Proposed PD - For Review

ISSUE DATE:
March 12, 2020

Re: Center Stage Planned Development
Keller, Texas

Concept Plan Changes

Open Space Plan Changes

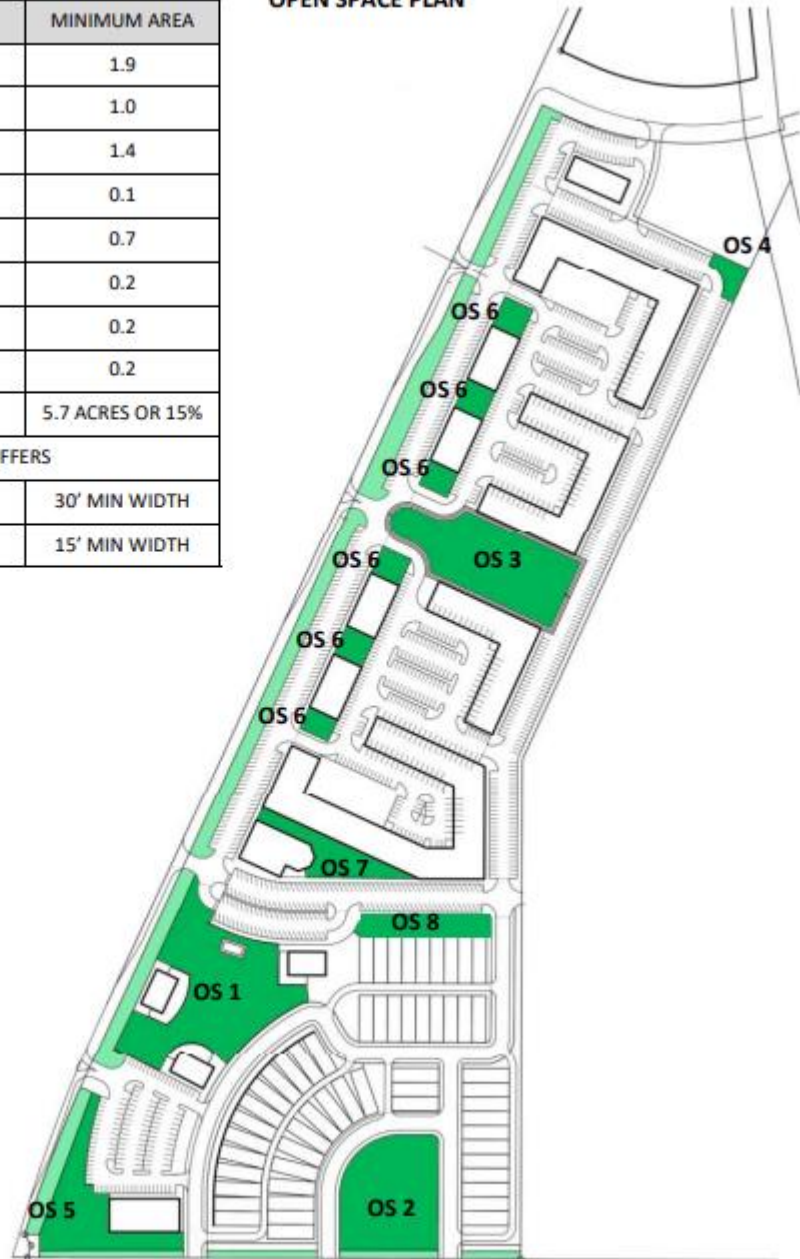
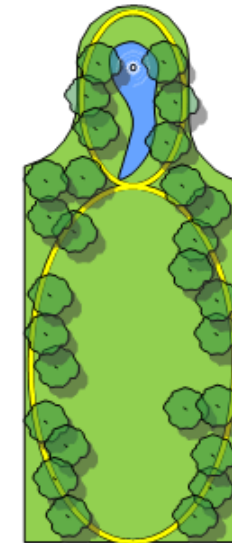
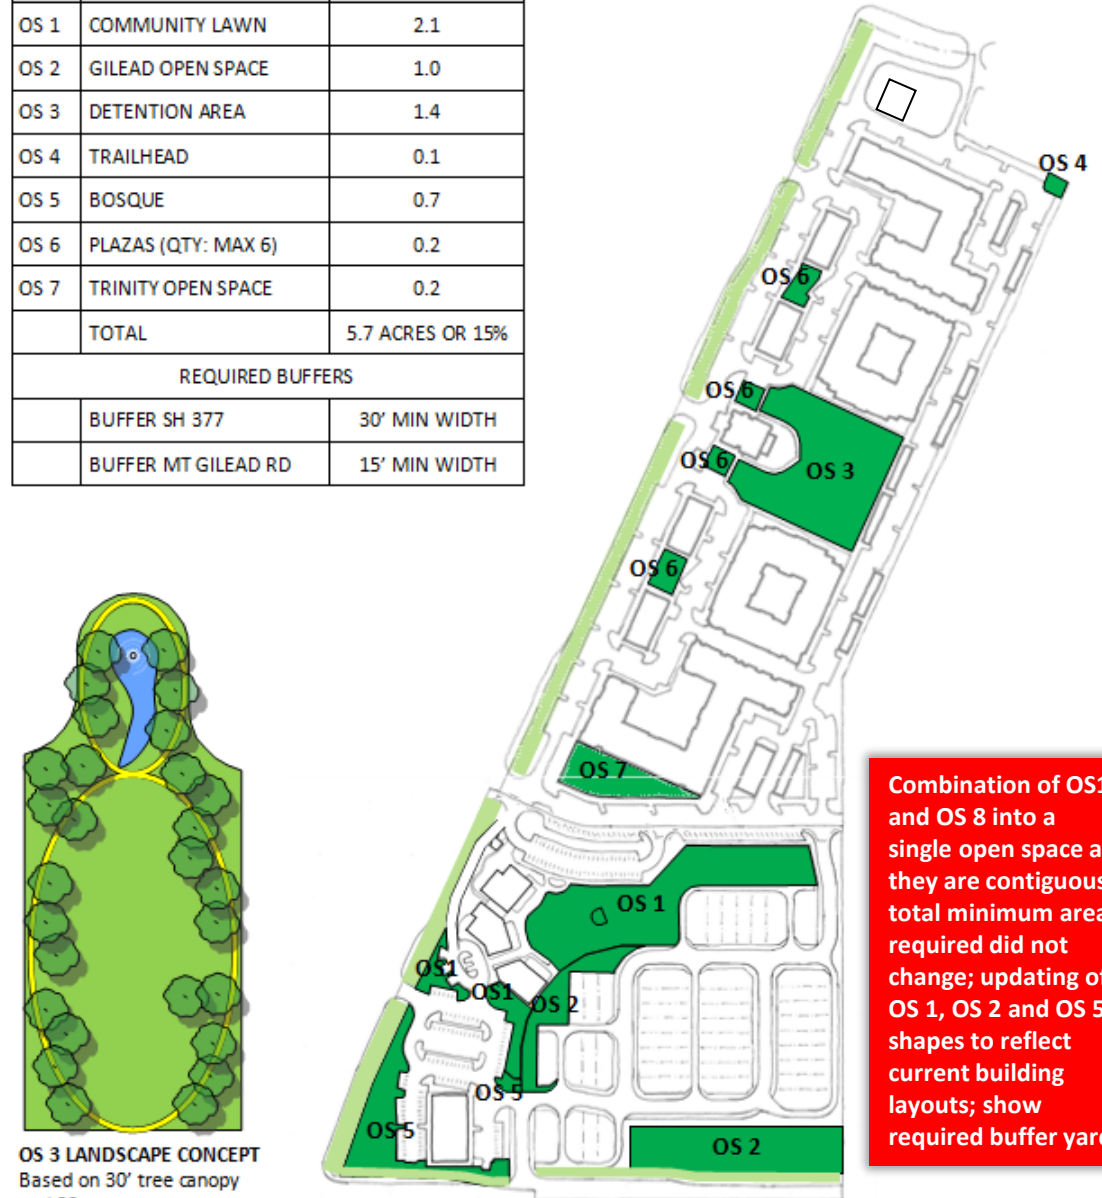
Combination of OS1 and OS 8 into a single open space as they are contiguous; total minimum area required did not change; updating of OS 1, OS 2 and OS 5 shapes to reflect current building layouts; show required buffer yard.

(P22): updated figure 5.1 and table 5.1 to remove Linear Park OS 8 and incorporate its 0.2 acre minimum into OS 1, illustrate OS 3's current configuration (its as-built condition exceeds the minimum 1.4 acre open space) and show the required buffer yard along 377 (30') and Mt Gilead (15')

Pedestrian Network Changes

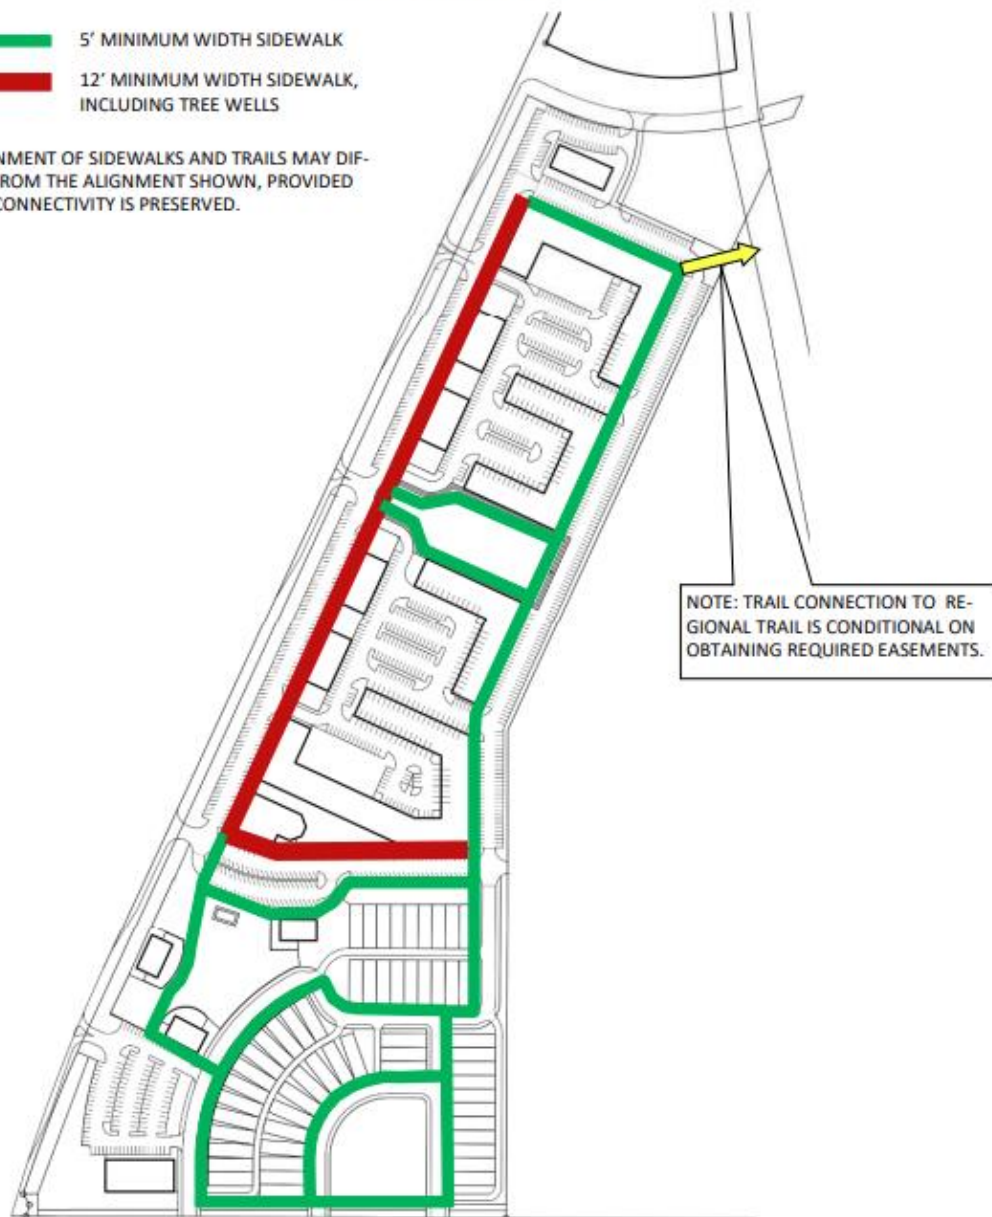
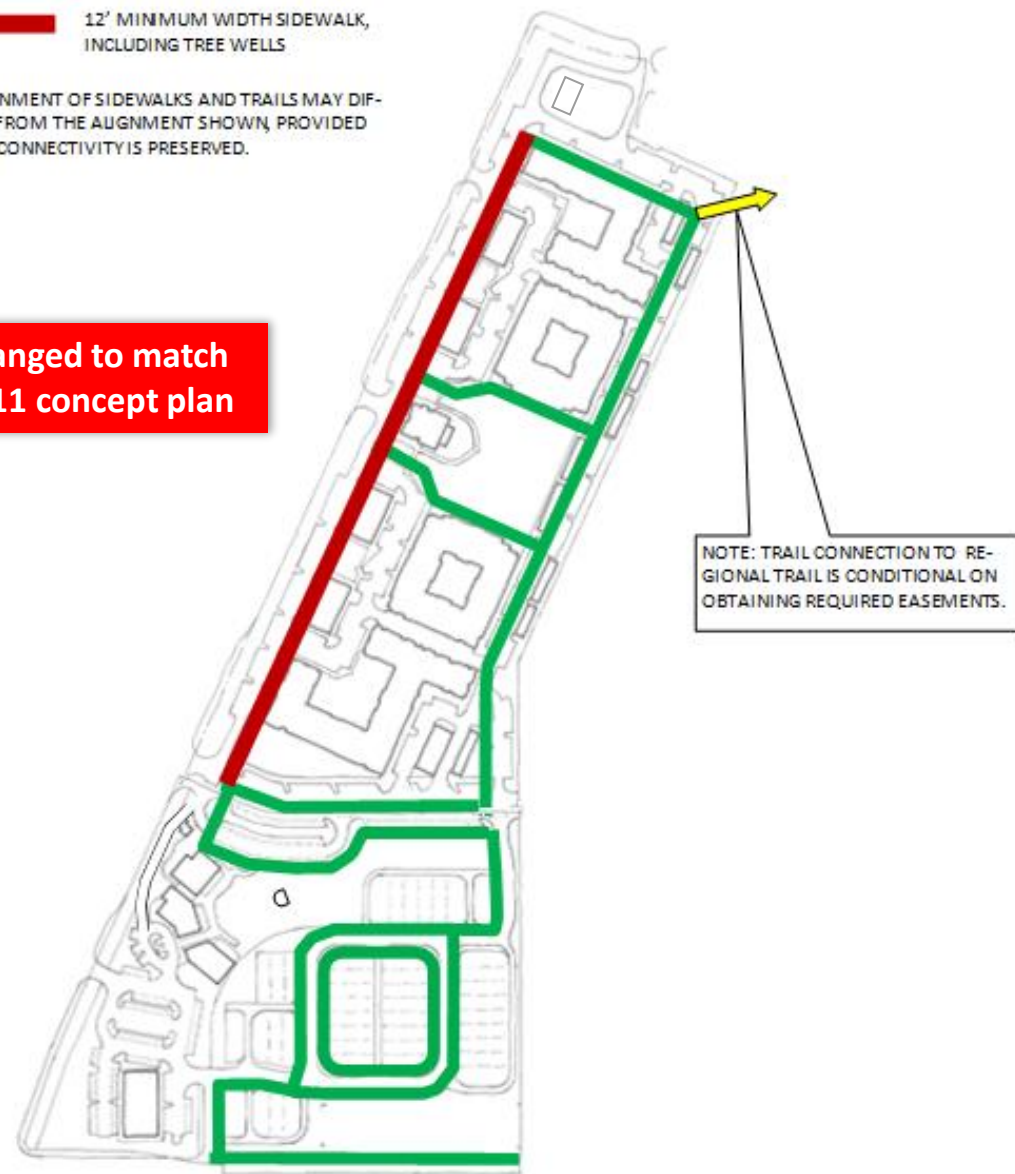
Changed to match
Pg 11 concept plan

(P25): updated figure 5.3

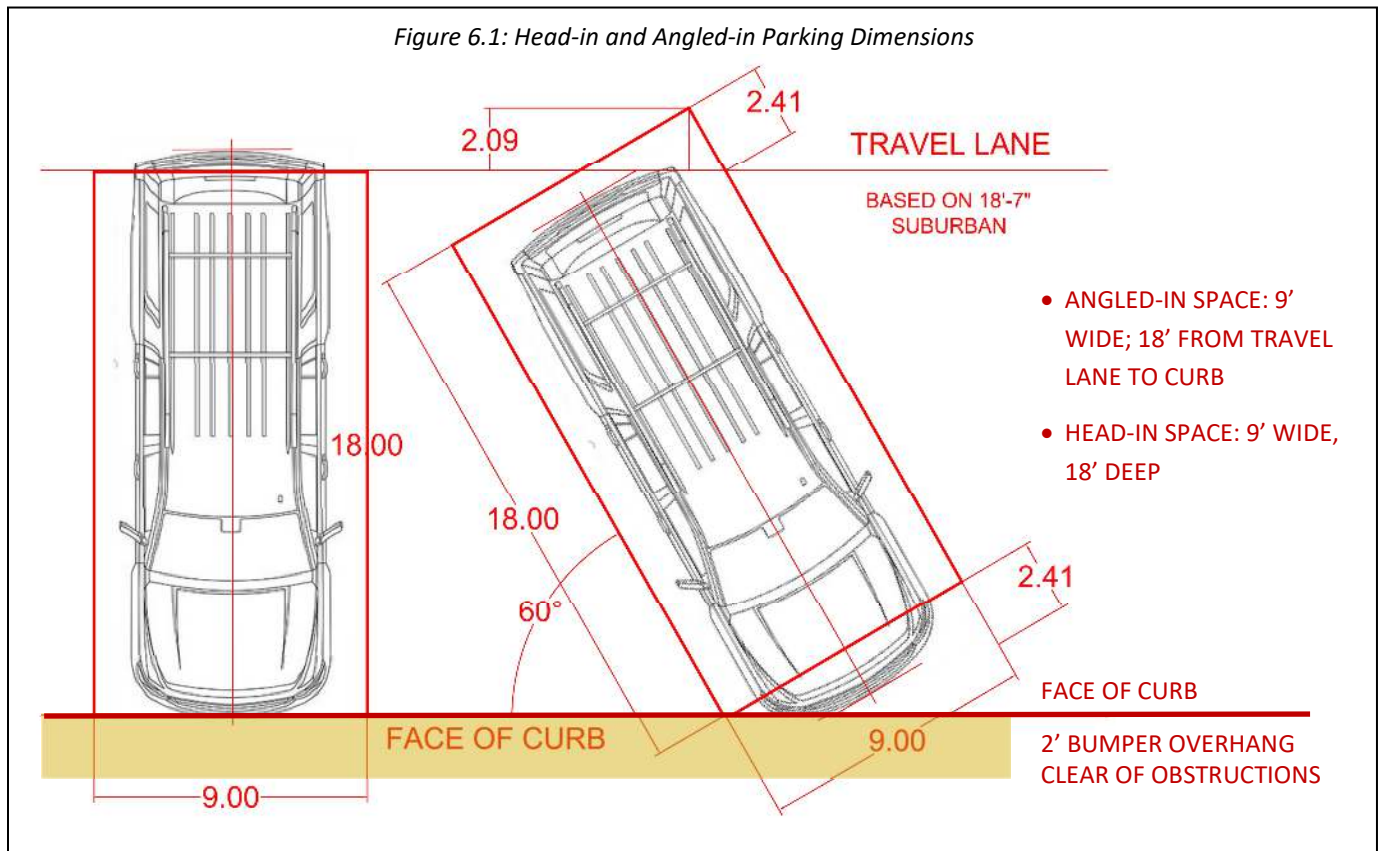
Updated Table 6.3 to reflect 43 single family home lots, 86 stalls required and 1,081 total required parking stalls instead of previous 57 lots/114 stalls/1,109 stalls

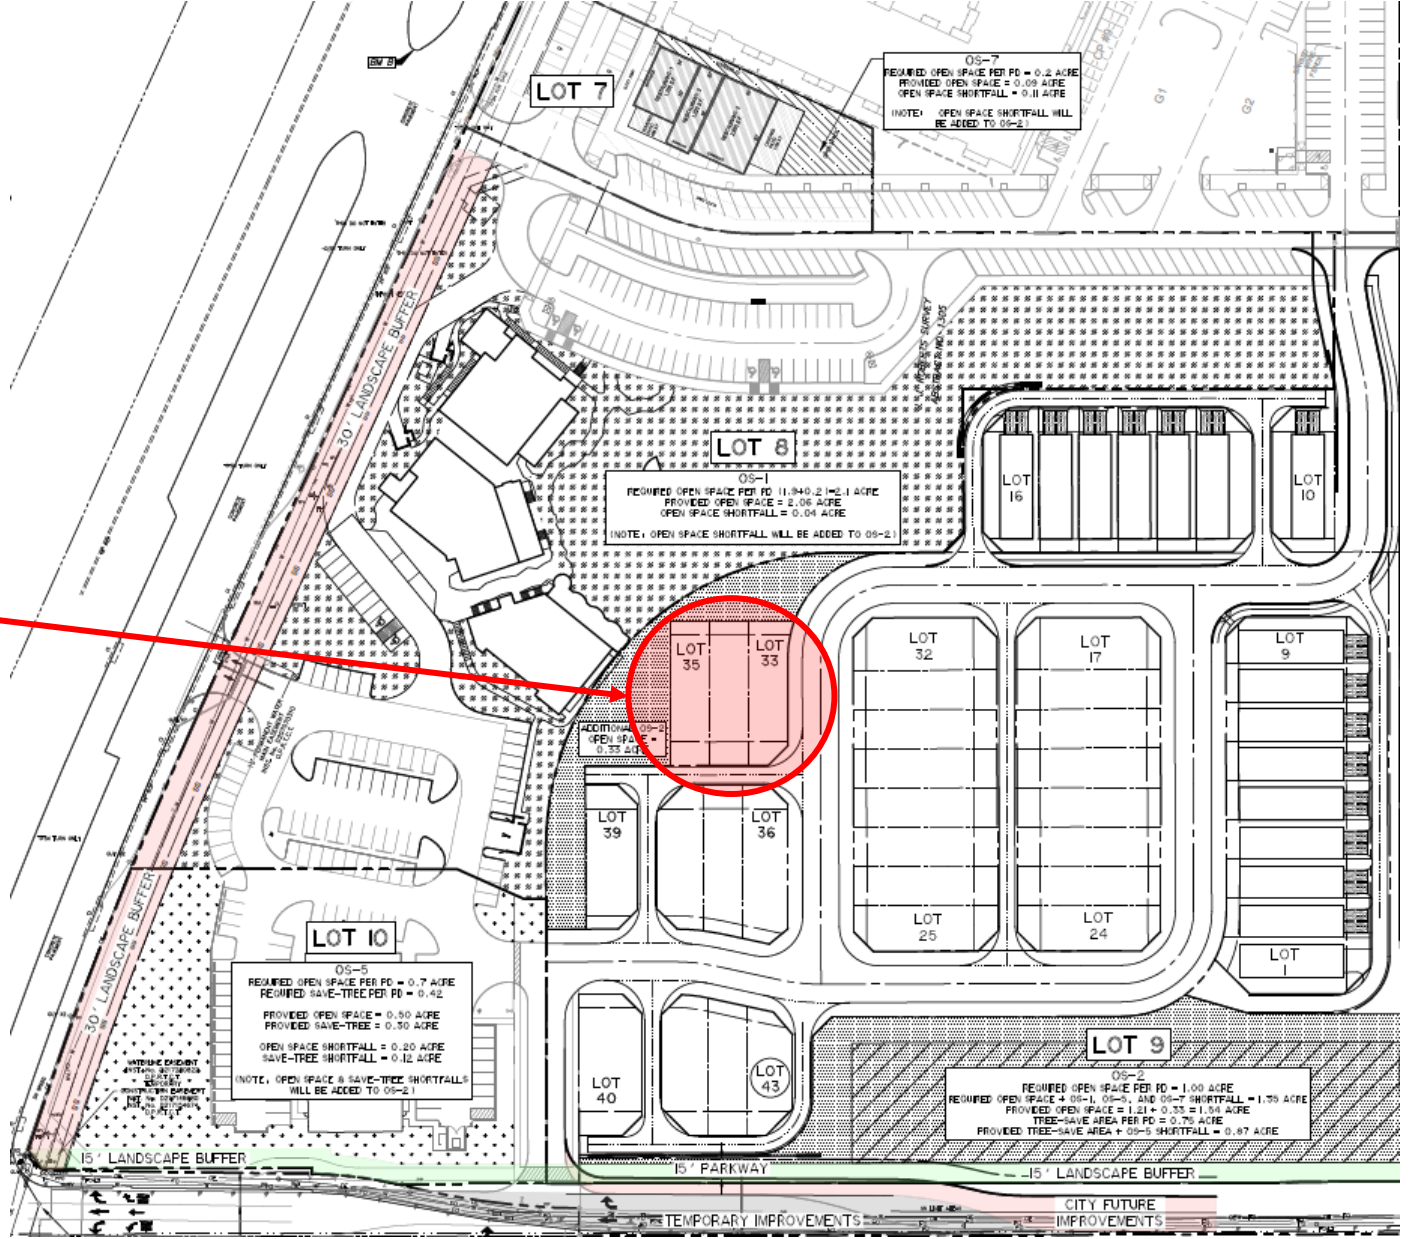
(P30): Added language to allow front doors on not more than ten percent (10%) of single-family home lots to face Center Stage/Community Lawn amenity in the absence of a public street directly adjacent to front façade of the homes

These 3 home lots do not front to a street, therefore we propose their front doors face the community lawn amenity.

(P30): Added language to allow front doors on not more than ten percent (10%) of single-family home lots to face Center Stage/Community Lawn amenity in the absence of a public street directly adjacent to front façade of the homes

Ground Floor Design Types Changes

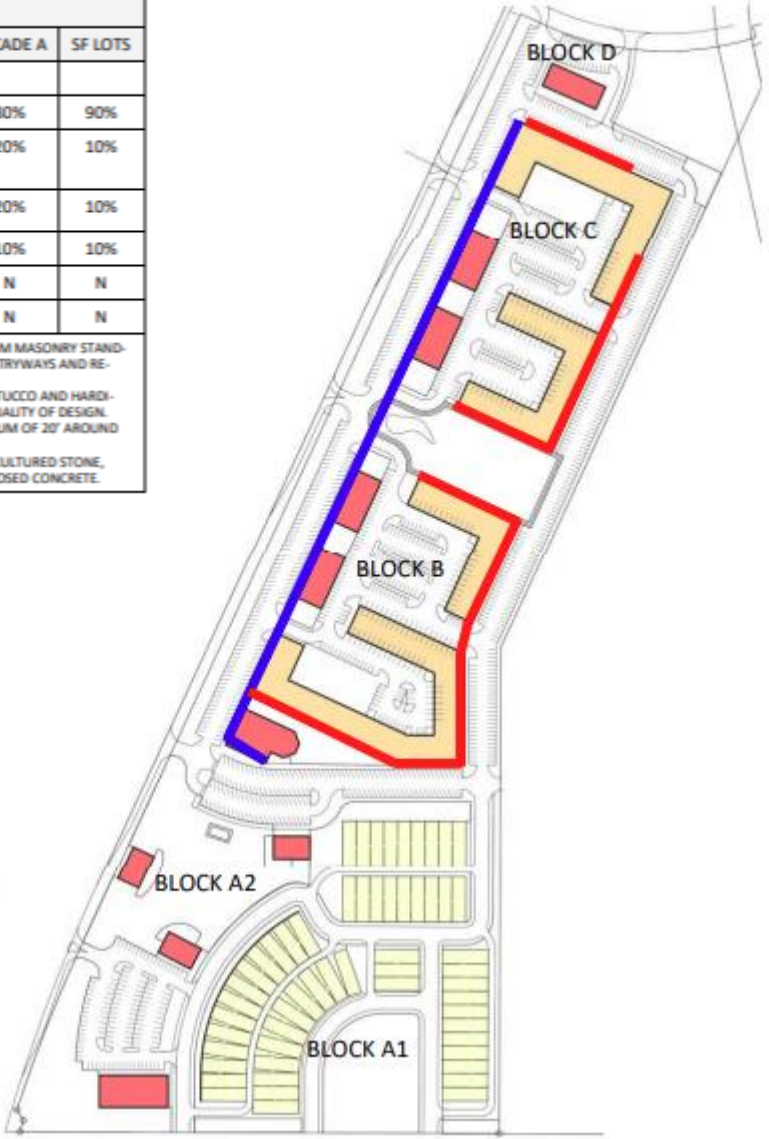
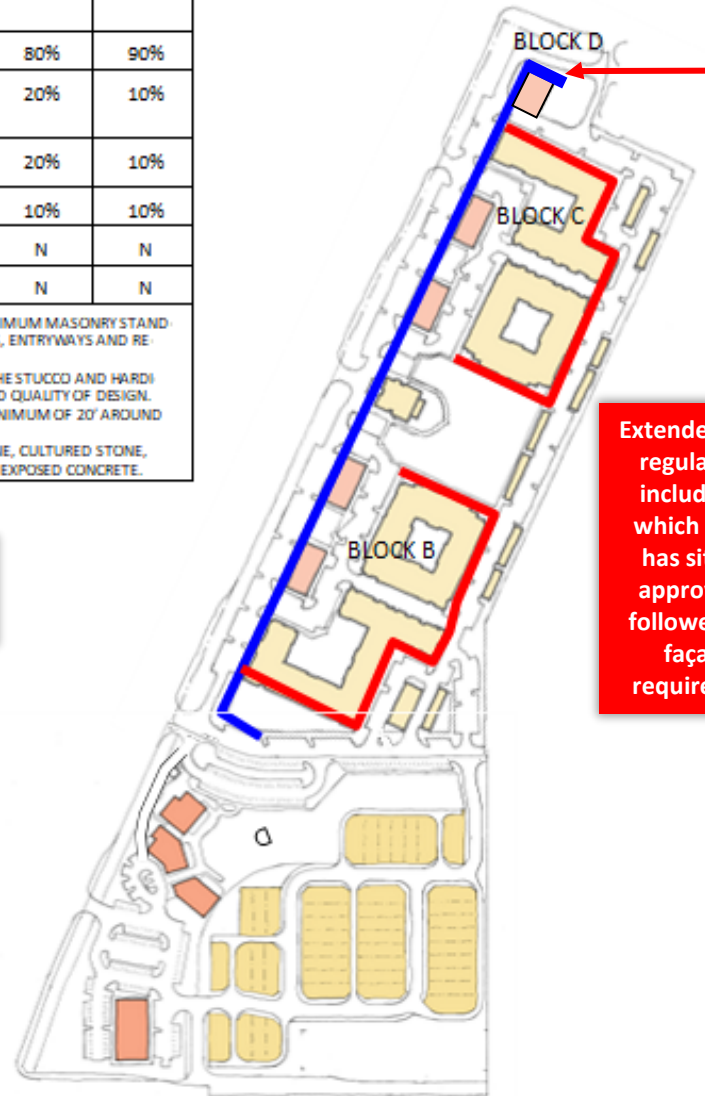
Changed to match
Pg 11 concept plan

Extended façade regulation to include lot 1, which already has site plan approval and followed these façade A requirements.

(P32): updated figure 7.2
